May 1, 2025

Re: Garcia's Kitchen
1736, 1766, AND 1776 Central Avenue SW,
Request for Waiver to Main Street Pedestrian Realm, 10'-12' Sidewalk Width, 6'-8'
Landscaping Buffer, and 1'-25' Frontage Zone, per DPM Table 7.2.29.

Aerial from 2018 obtained from COA Advanced Map Viewer.

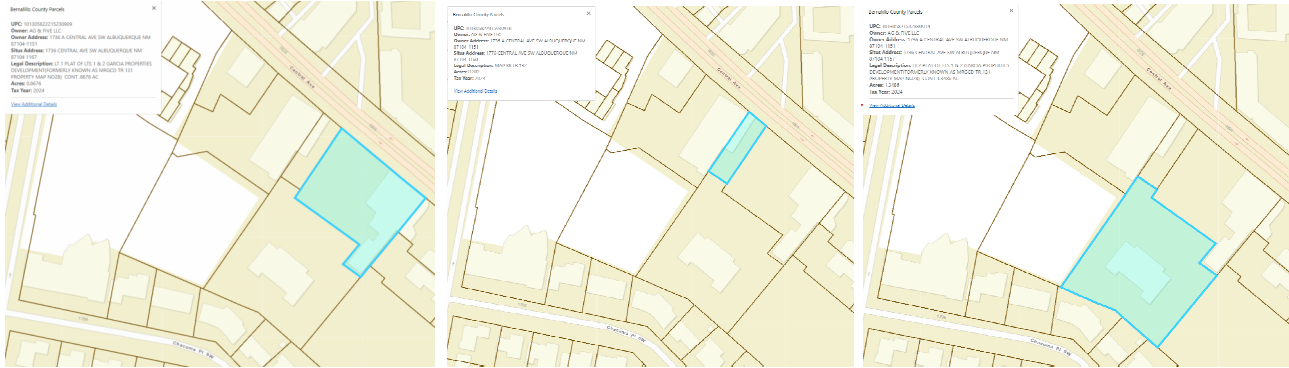
- ***Demonstrate compliance with section 7 of the DPM Table 7.2.29 regarding the 5-ft. Sidewalk width and 4-6 ft. landscape buffer width requirements.**
Verification of DPM standards per Transportation
 Central is a Main Street and requires 10' to 12' sidewalk with a 6' to 8' landscape buffer.
 Please provide documentation showing that you are meeting this requirement.

To start with, it should be noted that Central Avenue has been reconstructed a couple of time in the last 20 years. The first was when Councilor Ike Benton suggested that Central Avenue between the roundabout at 8th Street, to Lomas Boulevard was put on a lane diet. This lane diet reduced the traffic lanes from two lanes in each direction to a single lane each direction. While this seems counter to better traffic flow, the reduction in lanes has not caused any real concerns. As a resident of this area from 2008 to 2020 the lane reduction was a good thing. It slowed traffic and increase the walkability of the neighborhood (thank you Councilor Benton). To our recollection, none of the curb lines were moved inward as part of the lane diet project. Bulbouts were added in a few locations to better identify parallel parking locations.

The second rework was for the Albuquerque Rapid Transit (ART) project, that dedicated in center lane to the high capacity transit system. No adjustments to the southern curb lines were included in the ART reconfiguration project along the Garcia's Kitchen frontage.

The review comment related to the Main Street was introduced with the adoption of the Integrated Development Ordinance and rework of the Development Process Manual. According to a recent survey, the existing sidewalk is approximately 6'-8" wide. The attached survey shows obstructions such as light poles, and power poles that reduce the sidewalk width. The DPM does allow for narrower sidewalks, provided that a 10' minimum front setback is in place or provided. The sidewalks are in existing conditions. The current (or prior) buildings were constructed with a zero front setback.

The adjacent parcels also have the 6'-8" wide sidewalk and a zero front setback.
